Subject:
Response to Supplemental Environmental Assessment and No Further Action
Request Comment Letter (September 10, 2020)
Former Arvin Industries
1001 Hurricane Street
Franklin, Johnson County, Indiana 46131
State Cleanup Site # 0000783

Date:
October 27, 2020

**Re: Response to Comments, Supplemental
Environmental Assessment Report and No
Further Action Request**
Former Arvin Industries
1001 Hurricane Street
Franklin, Johnson County
State Cleanup Site #0000783

Further Site Investigation Activities

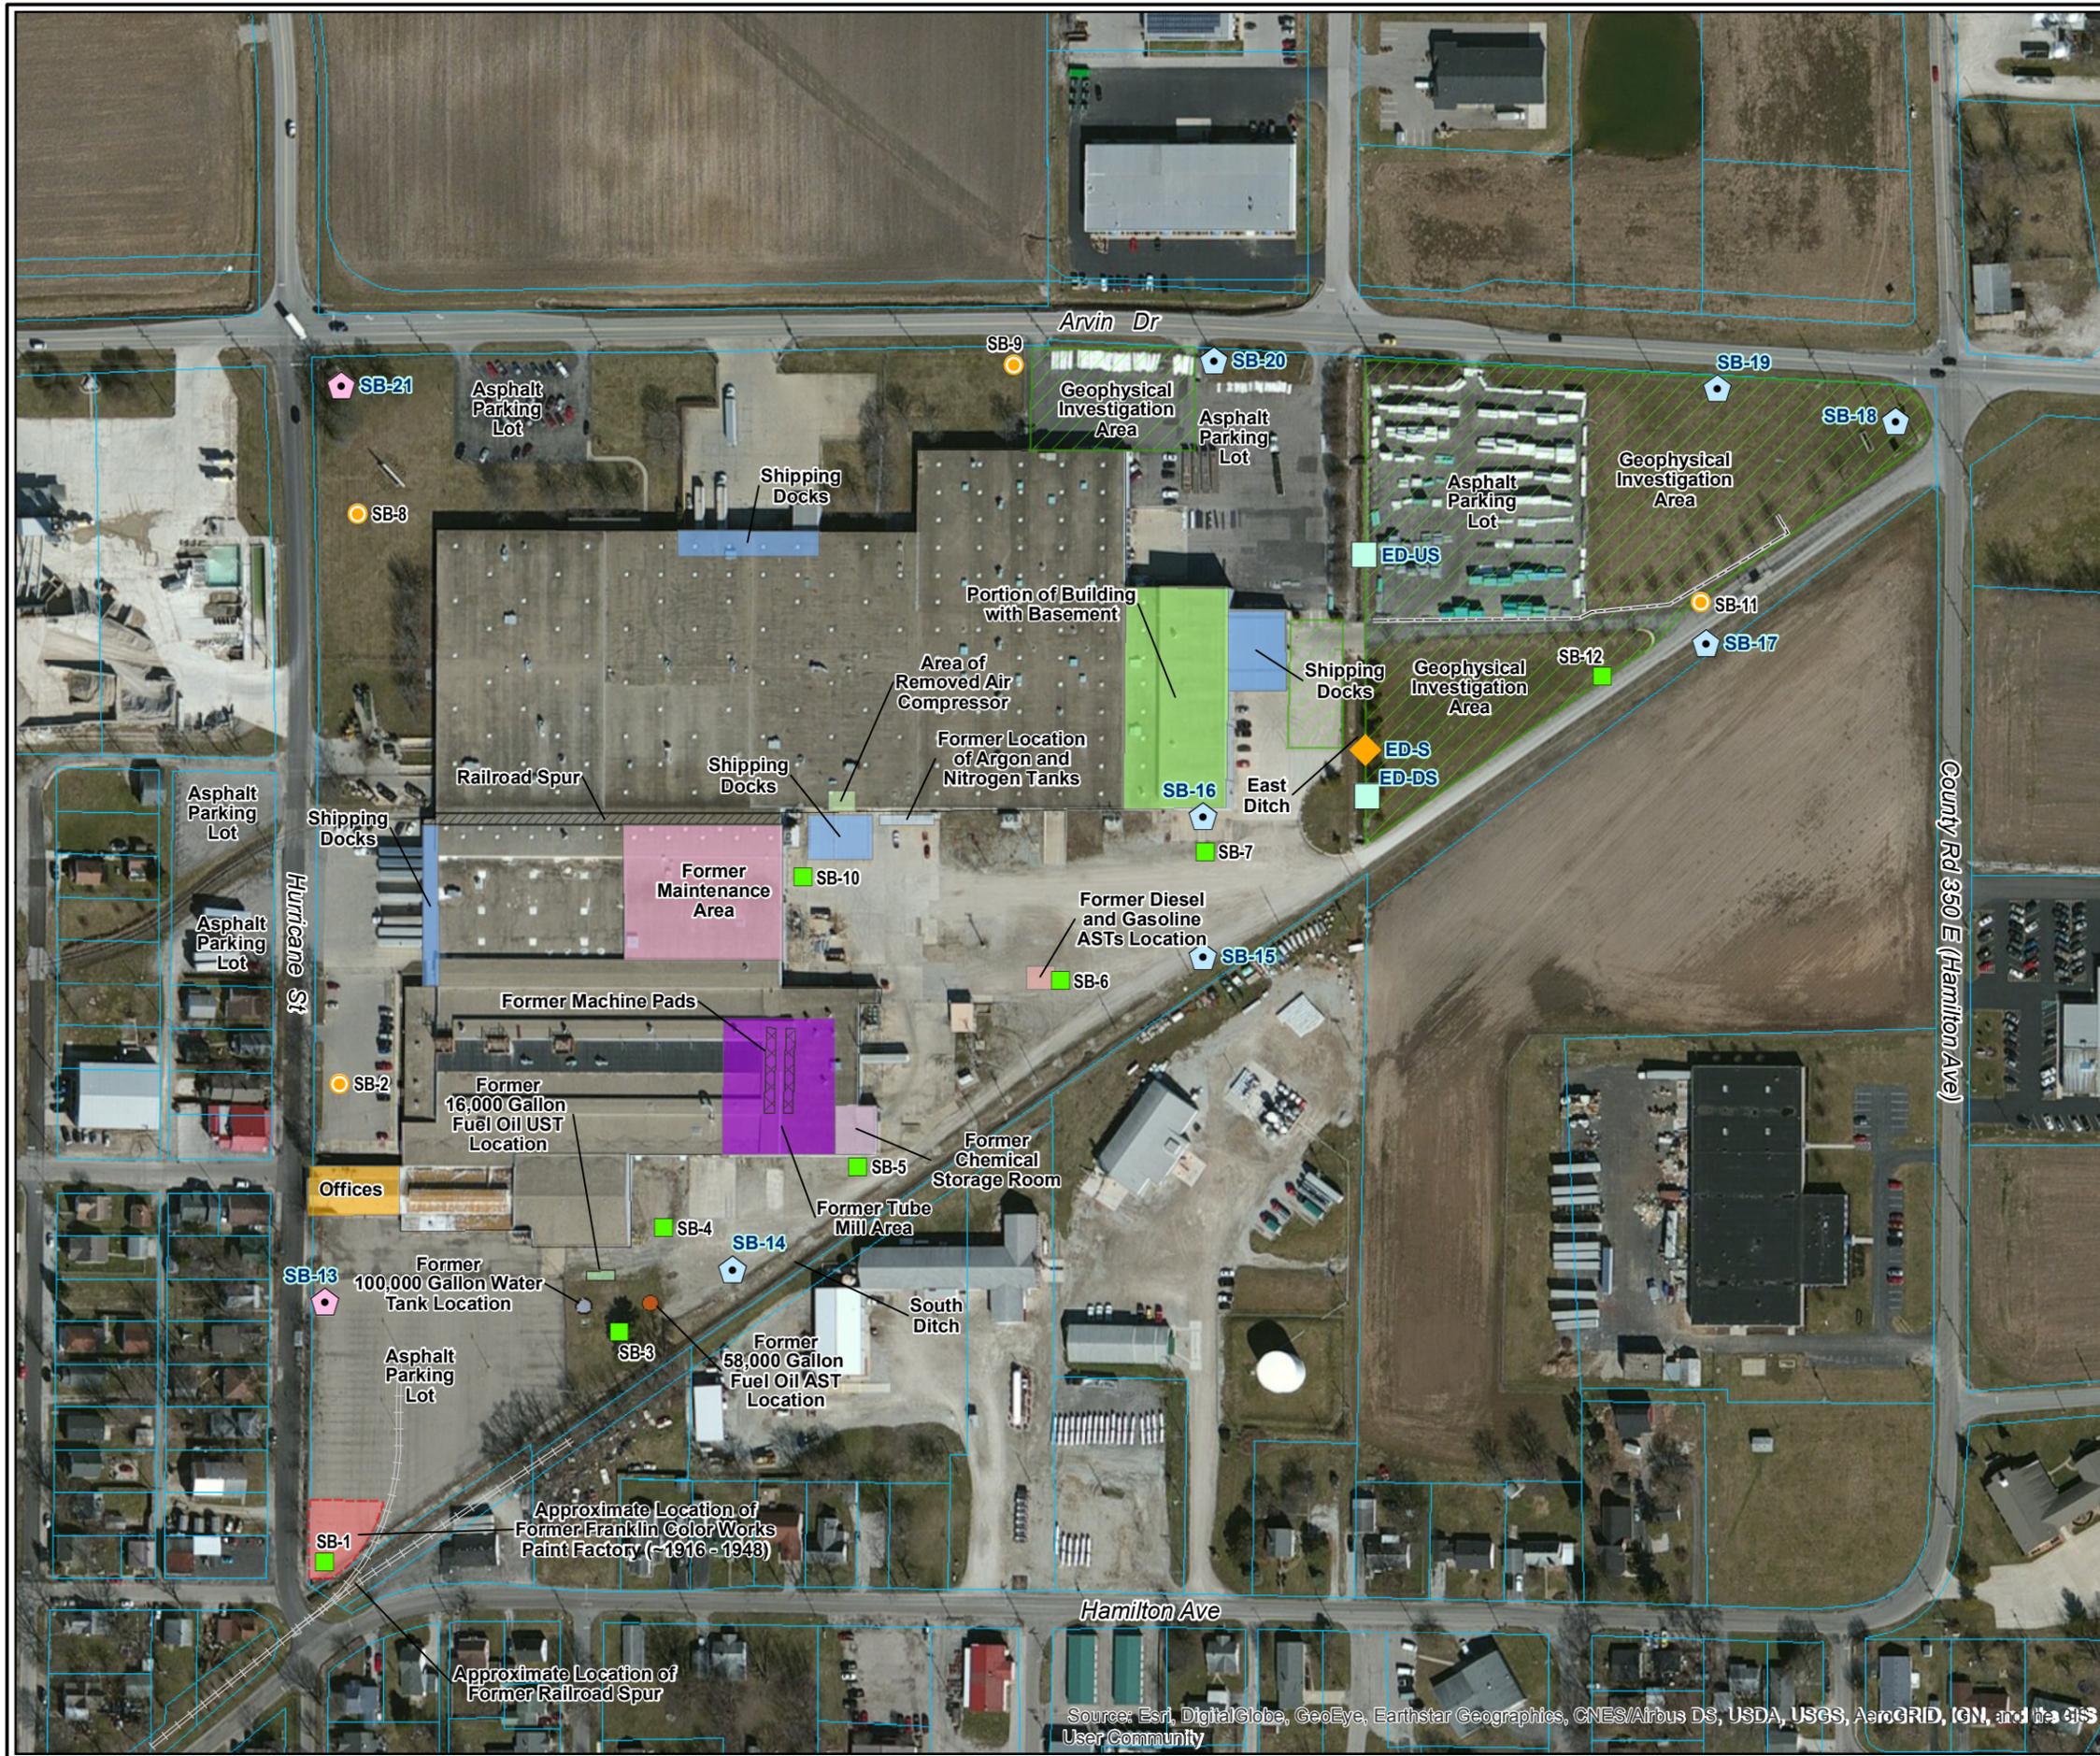
3. *Two surface water samples (ED-US and ED-DS) and one sediment sample (ED-S) were collected from the east drainage ditch (Figure 2) per IDEM's request in the November 25, 2019 comment*

3. Two surface water samples (ED-US and ED-DS) and one sediment sample (ED-S) were collected from the east drainage ditch (**Figure 2**) per IDEM's request in the November 25, 2019 comment letter. The surface water and sediment samples were analyzed for volatile organic compounds (VOCs). The data results were compared to the default IDEM Screening and Closure Level scenarios published in the 2019 RCG, Table A-6, and are presented in **Tables 3** and **4**. None of the samples collected from the east ditch contained VOCs above laboratory detection limits.

Meritor and Arcadis agree with this comment.
